MR70 ground system mods

MR70 GROUND WIRING - REPRO

MRTD GROUND WIRING - RECORD

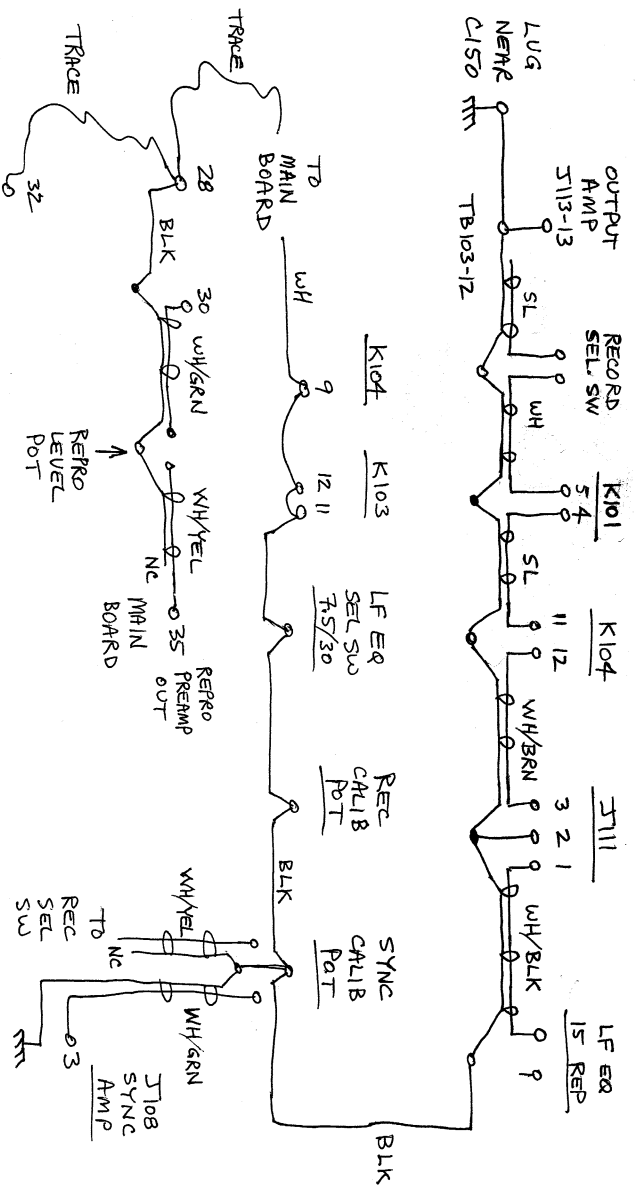
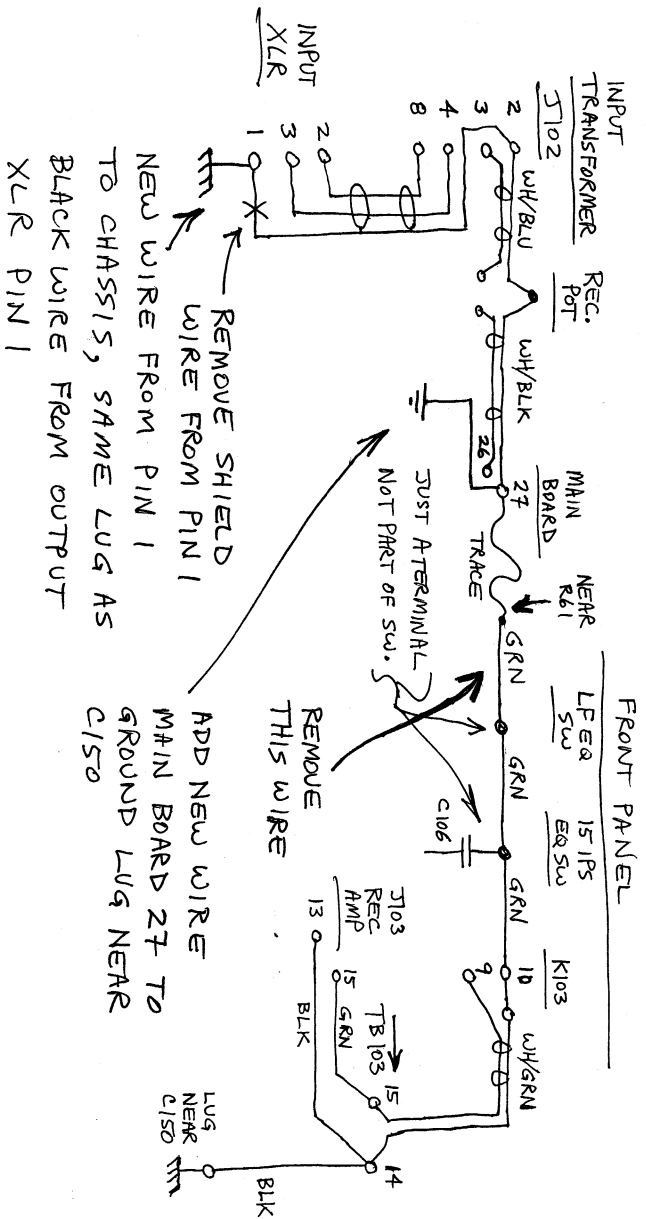
- 1) XLR input: Remove shield from pin 1.
Tie pin 1 to chassis - same lug on TB102 as used for XLR output pin 1.
- 2) Cut green wire from front of main board near R61 to lug on 15 ips LF EQ switch.
- 3) Add wire from main board terminal 27 to ground lug near C150.
- 4) Dync Calib pot: remove black wire to shields of 2 cables connected to other 2 terminals of this pot.
